TO: DEVELOPMENT REVIEW BOARD
FROM: CURRENT PLANNING SERVICES
SUBJECT: CASE 98-DR-2003
REQUEST: Approve site plan & elevations for a new Senior Center at McDowell Village
PROJECT NAME: Scottsdale Senior Center, McDowell Village
LOCATION: 8302 E McDowell Rd

Stipulations for Case: Scottsdale Senior Center – McDowell Village 98-DR-2003

SITE PLAN
SCALE: 1" = 40'-0"

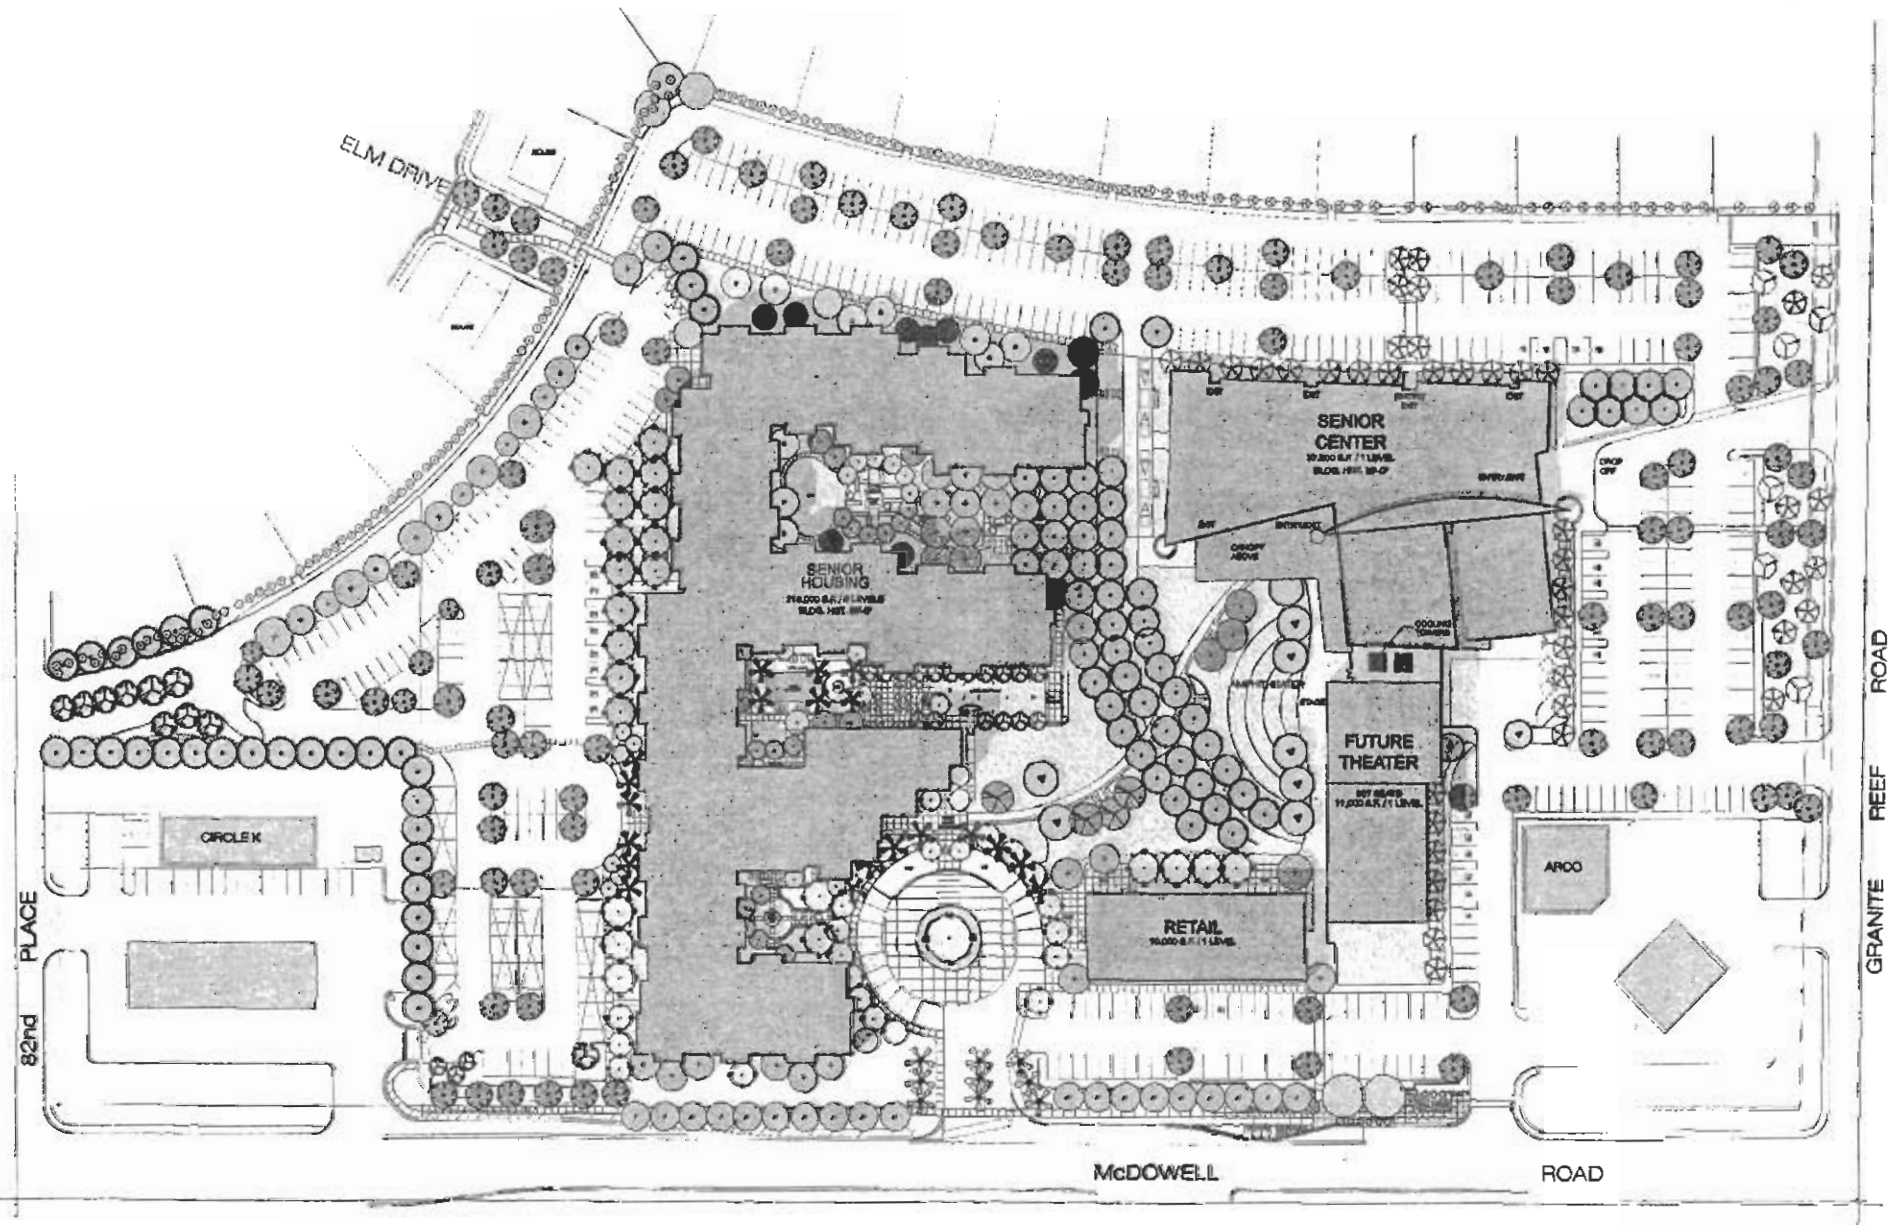
- f. Enclosures serviced on one side of a drive must be positioned at a 30-degree angle to the centerline of the drive.
35. The refuse location identified on the referenced applicable documents south of the Senior Center must be modified to accommodate a double enclosure with grease containment City of Scottsdale Supplements to MAG Standards, standard detail #2147-2. This location also must be modified to accommodate the trash requirements of the future theater and retail pads.
